SUBJECT: DONALD C. COOK NUCLEAR PLANT, UNITS 1 AND 2 - AMENDMENT NOS. 168  
AND 151 TO FACILITY OPERATING LICENSE NOS. DPR-58 AND DPR-74  
(TAC NOS. M79832 AND M79833)

AMENDMENT NO. 168 TO FACILITY OPERATING LICENSE NO. DPR-58-D. C. COOK  
AMENDMENT NO. 151 TO FACILITY OPERATING LICENSE NO. DRP-74-D. C. COOK

ATTACHMENT TO LICENSE AMENDMENT NO. 168  
TO FACILITY OPERATING LICENSE NO. DPR-58  
DOCKET NO. 50-315

SAFETY EVALUATION BY THE OFFICE OF NUCLEAR REACTOR REGULATION  
RELATED TO AMENDMENT NO. 168 TO FACILITY OPERATING LICENSE NO. DPR-58  
AND AMENDMENT NO. 151 TO FACILITY OPERATING LICENSE NO. DPR-74  
INDIANA MICHIGAN POWER COMPANY  
DONALD C. COOK NUCLEAR PLANT, UNIT NOS. 1 AND 2  
DOCKET NOS. 50-315 AND 50-316

FIGURE 2.1-1 REACTOR CORE SAFETY LIMITS

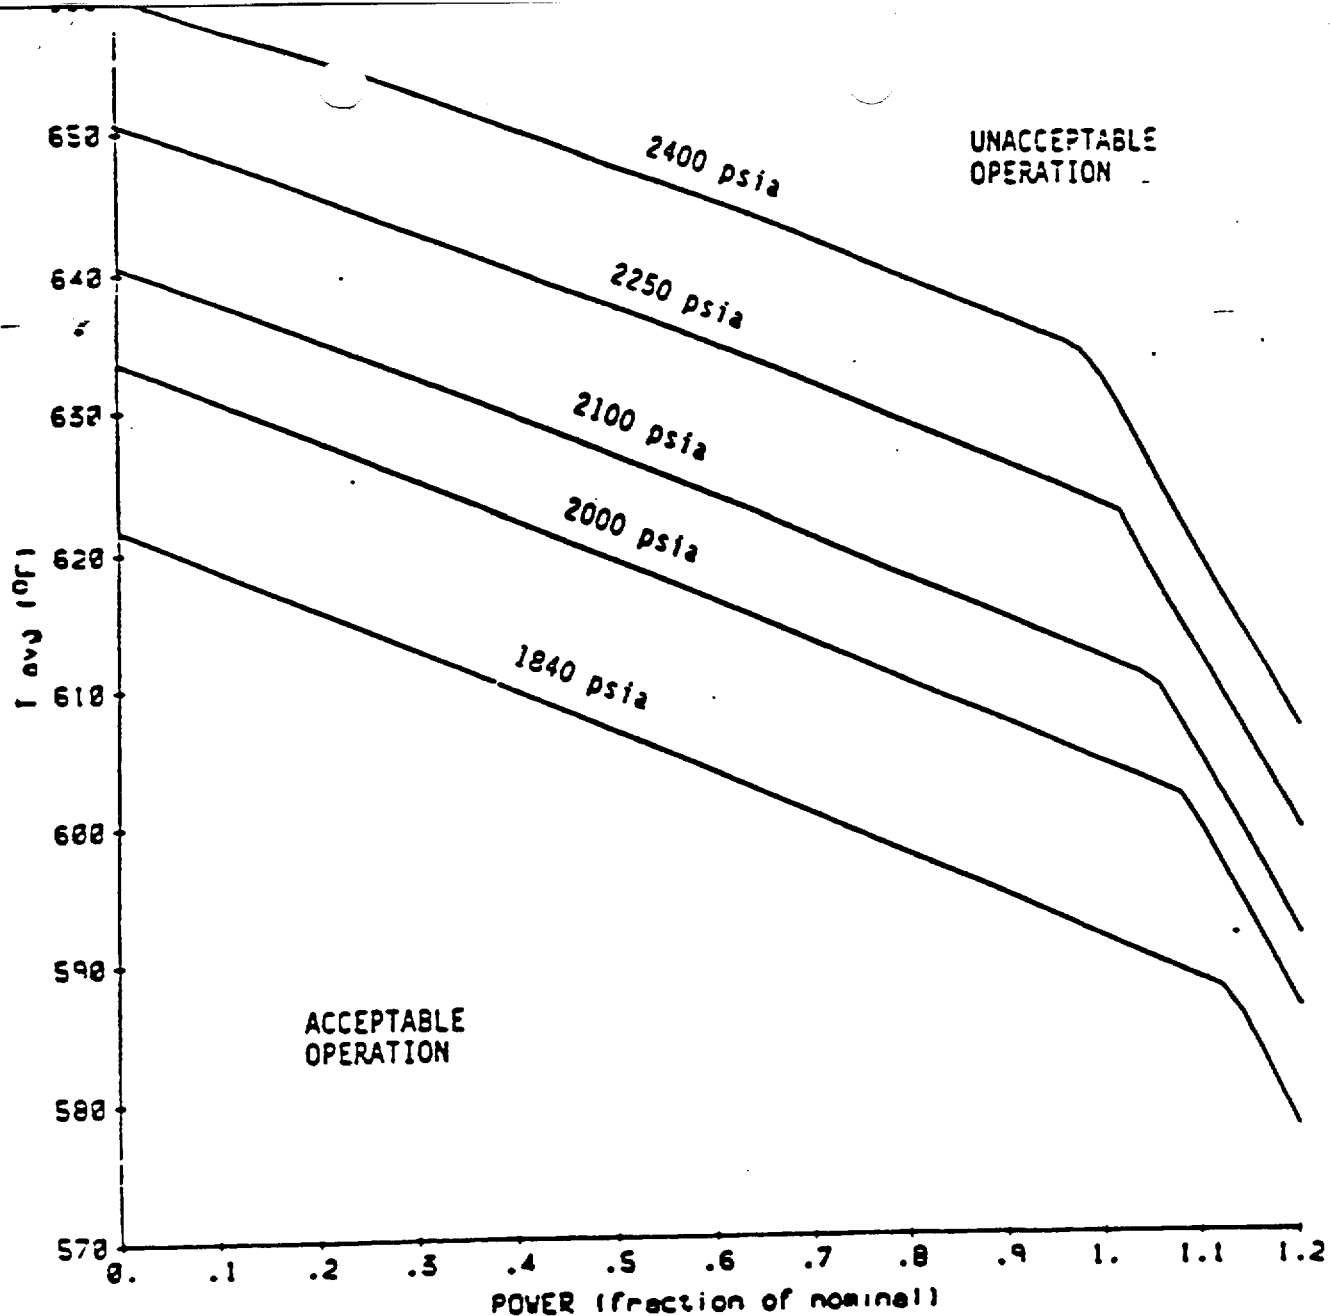
- a. (3) Adds the word "average" to the limiting condition for operation in TS 2.1.1 to provide clarification.
- b. (4) Change rated thermal power on TS page 2-2, Unit 1, "3414 MWT" to match licensed rated thermal power of "3250 MWT."
- c. (5) Change functional unit 17.A in Table 2.2-1 from "Low Trip System Pressure" to "Low Fluid Oil Pressure" to reflect proper terminology.
- d. (12) Change the name of the plant computer in Unit 1, TS Table 3.3-11 and Unit 2, TS Table 3.3-10 to reflect the installation of the new plant process computer.
- e. (18) The terms "inlet" and "outlet" are being corrected in Table 3.6-1 in both units TS to reflect the proper reference terminology used by operators.
- f. (19) Add descriptive terms to differentiate between auxiliary feedwater pumps in TS 4.9.7.1 for both units.

2.1.1 The combination of THERMAL POWER, pressurizer pressure, and the highest operating loop coolant average temperature ( $T_{avg}$ ) shall not exceed the limits shown in Figure 2.1-1 for 4 loop operation.
